**RE: Wilshire Subdivision
Grading & Drainage Plan
Engineer's Stamp Date: 03/08/23
Hydrology File: C20D089**

Based upon the information provided in your submittal received 03/09/2023, the Grading & Drainage Plan is approved for action by the Development Hearing Officer (DHO) on Preliminary/Final Plat.

Project Title: WILSHIRE PLACE SUBDIVISION **Building Permit #:** _____ **Hydrology File #:** C20

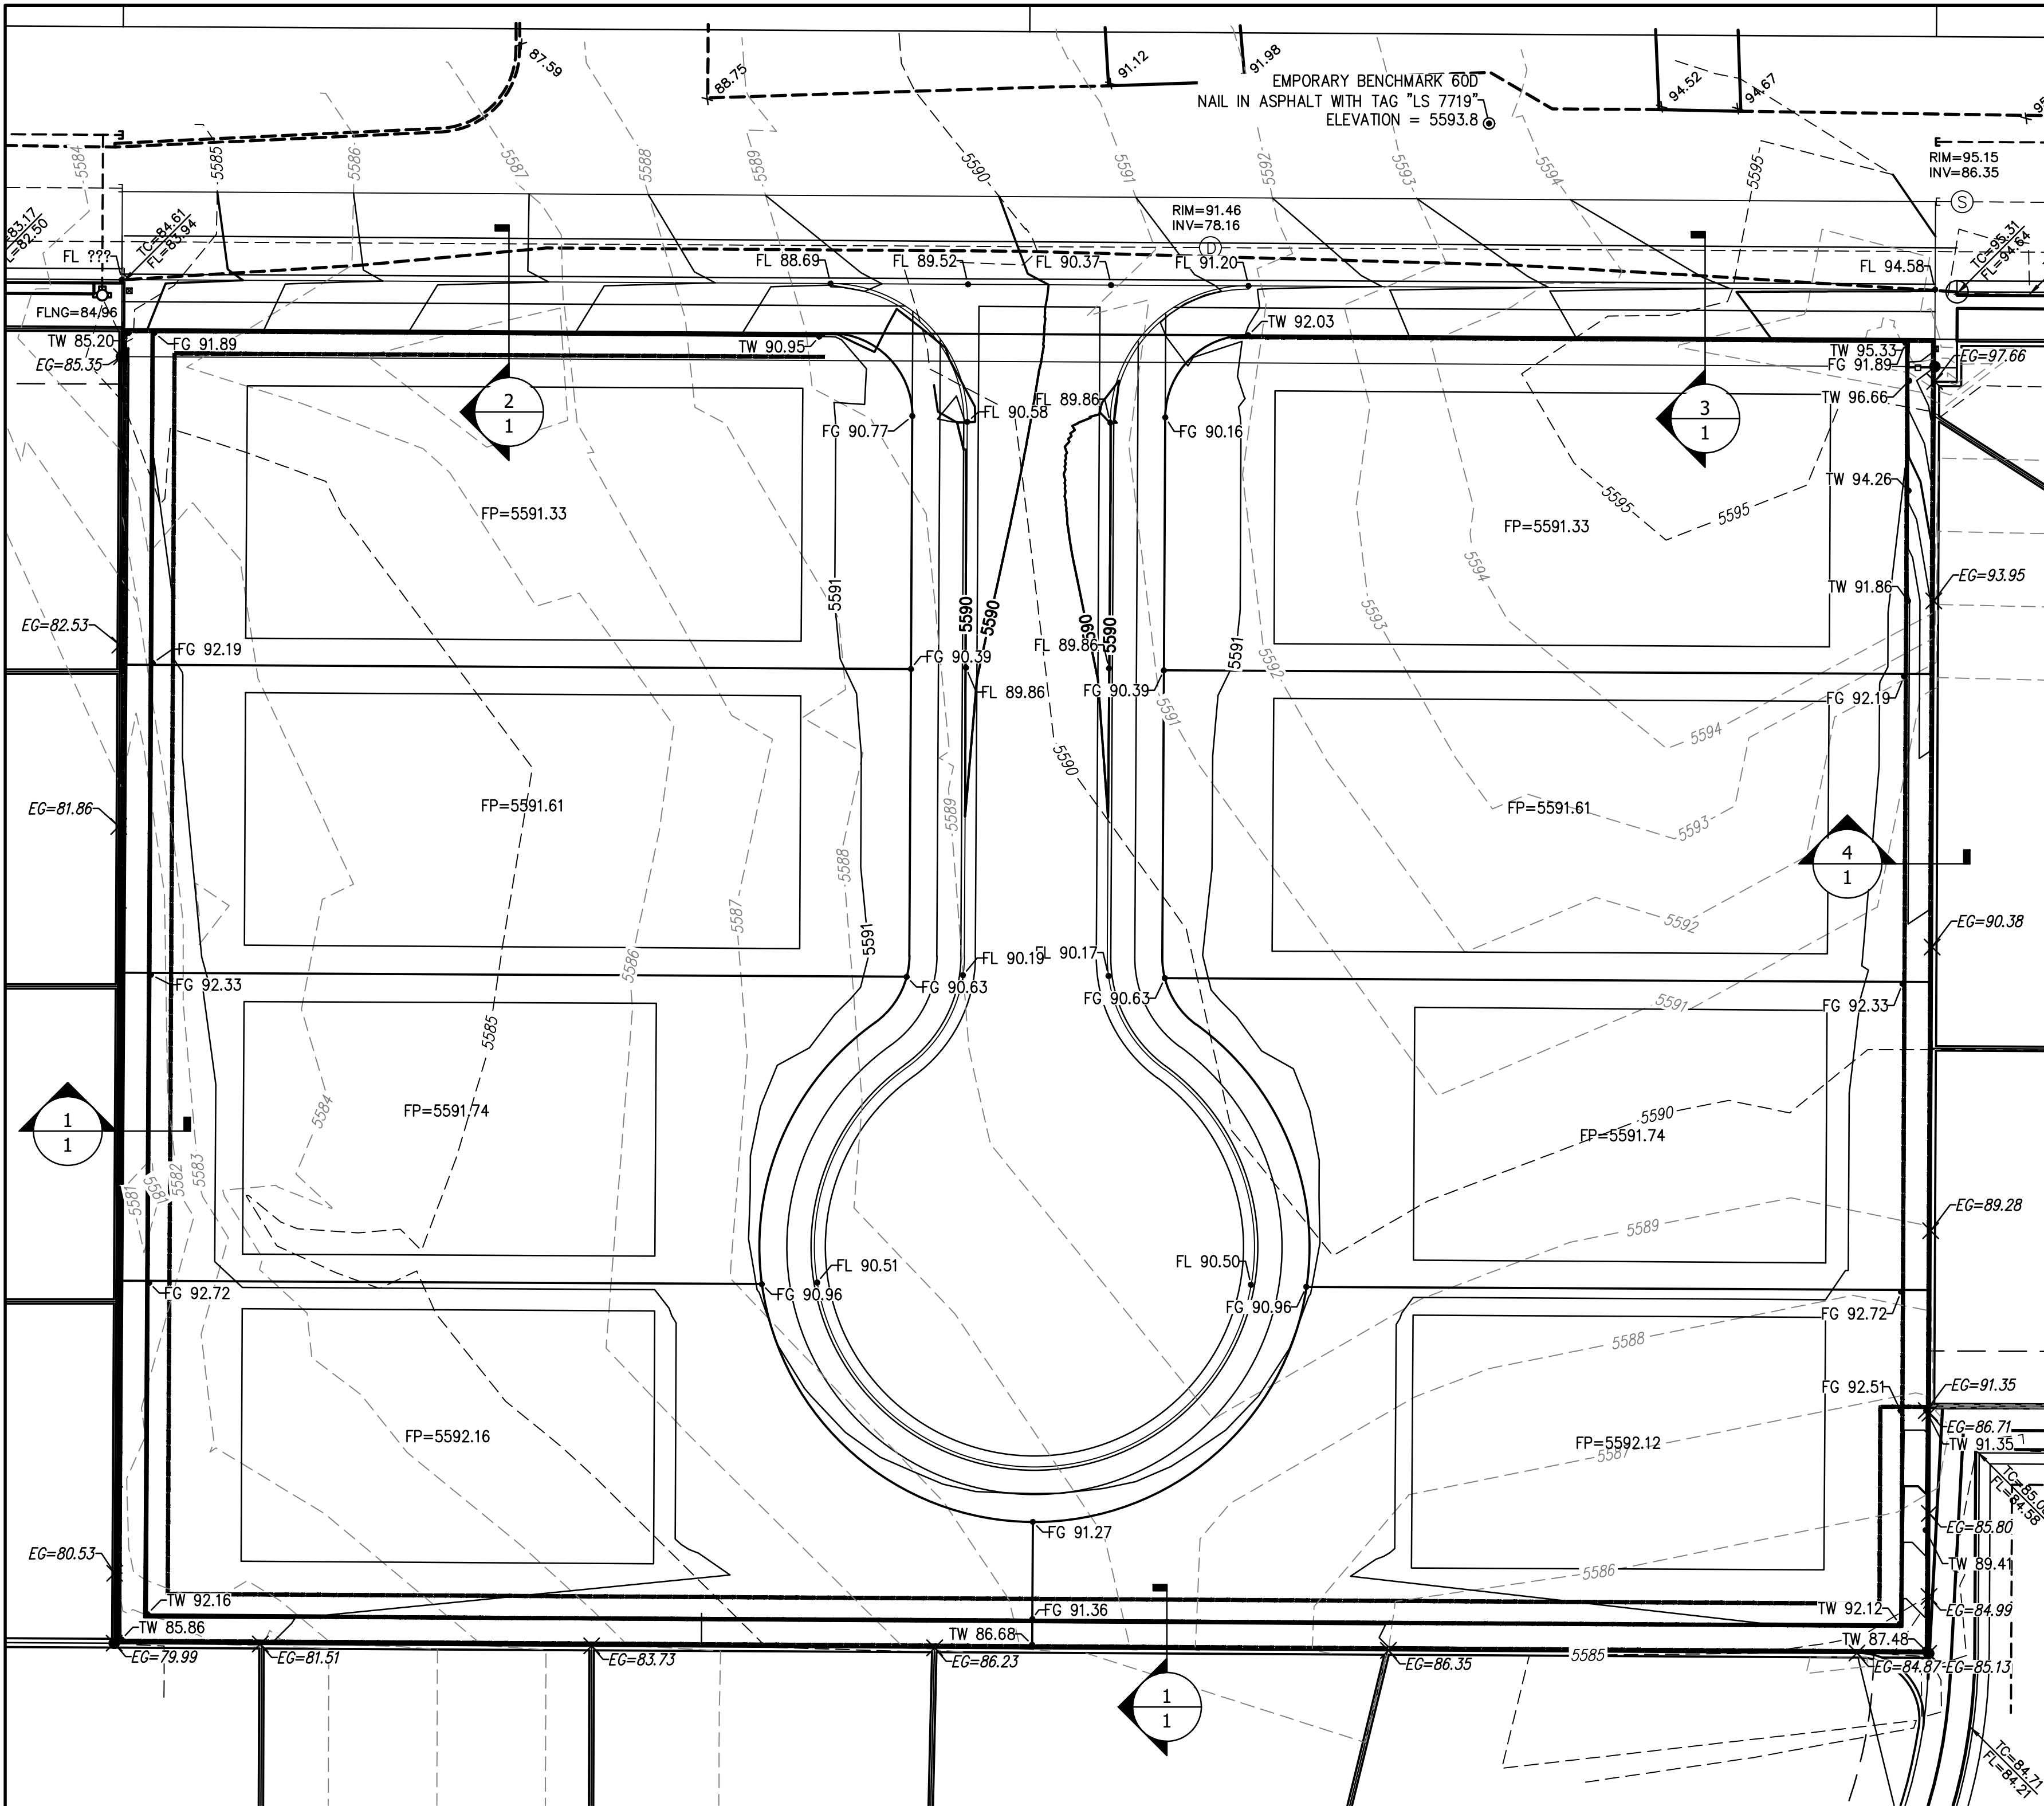
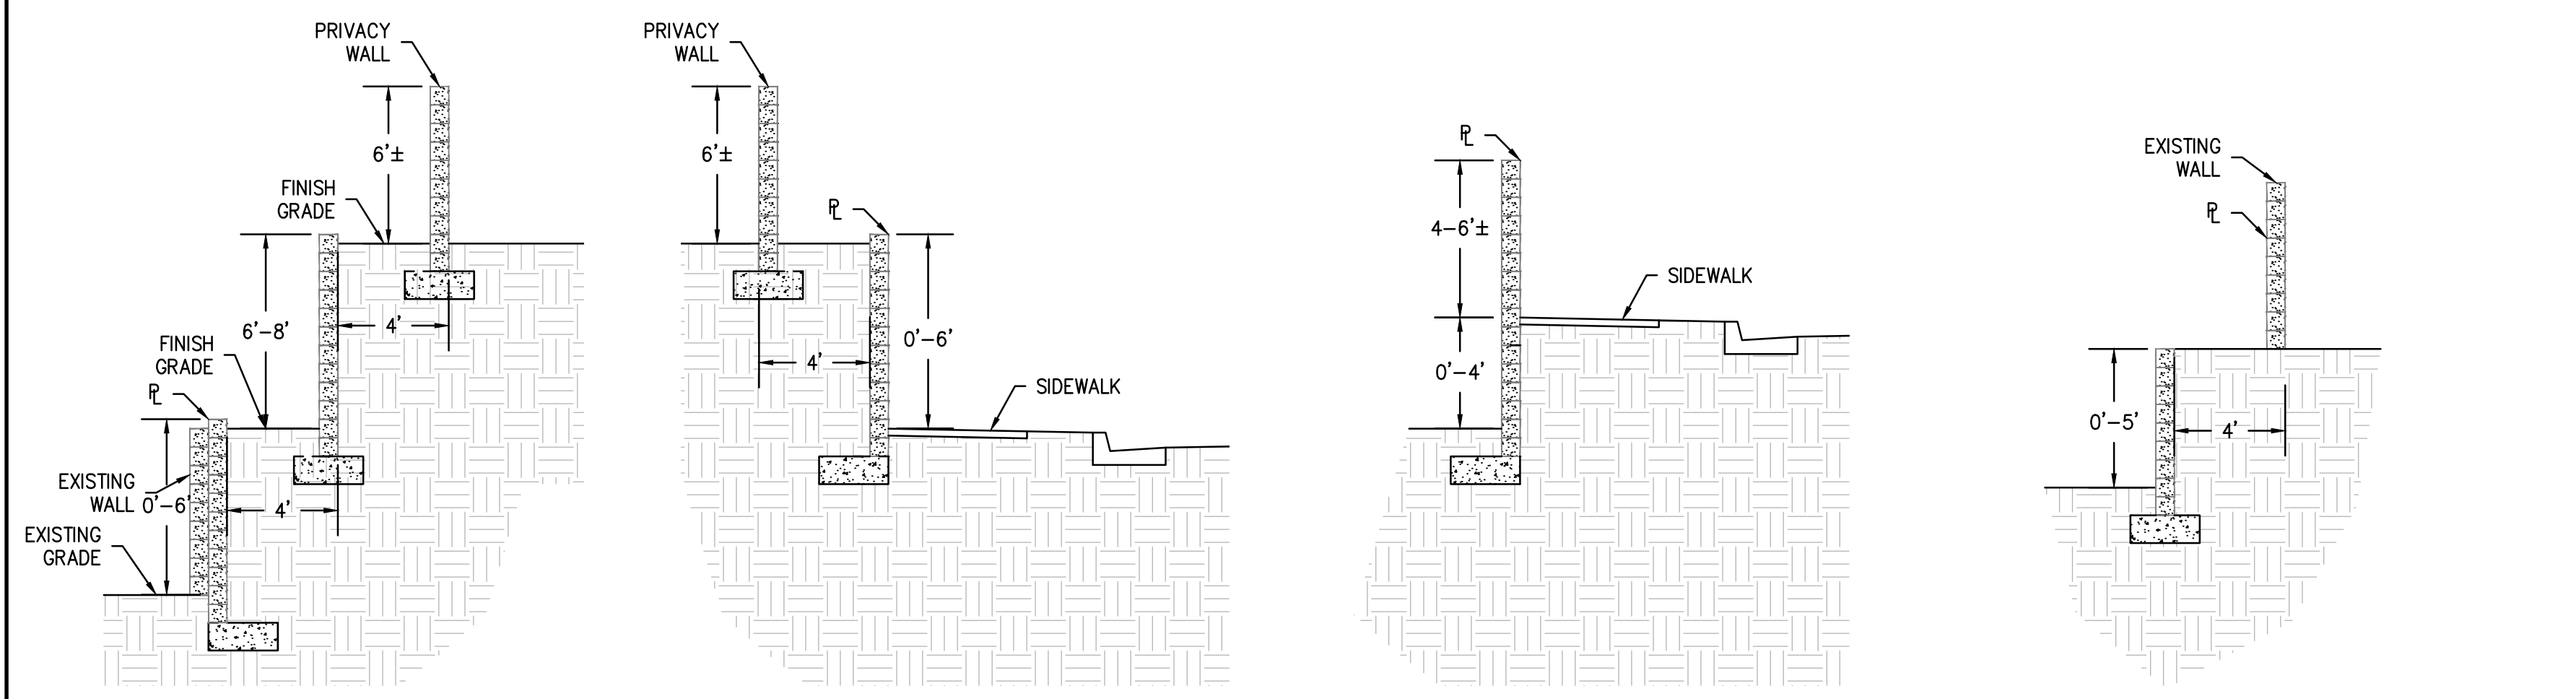
1. Please submit the Grading & Drainage Plan to Hydrology for review and approval for Work Order and Grading Permit. Please also include a filled-out Waiver form for On-site Stormwater Quality Pond. The payment-in-lieu will have to be paid prior to Work Order close out. This digital (.pdf) is emailed to PLNDRS@cabq.gov along with the Drainage Transportation Information Sheet.

As a reminder, if the project total area of disturbance (including the staging area and any work within the adjacent Right-of-Way) is 1 acre or more, then an Erosion and Sediment Control (ESC) Plan and Owner's certified Notice of Intent (NOI) is required to be submitted to the Stormwater Quality Engineer (Doug Hughes, PE, jhughes@cabq.gov, 924-3420) 14 days prior to any earth disturbance.
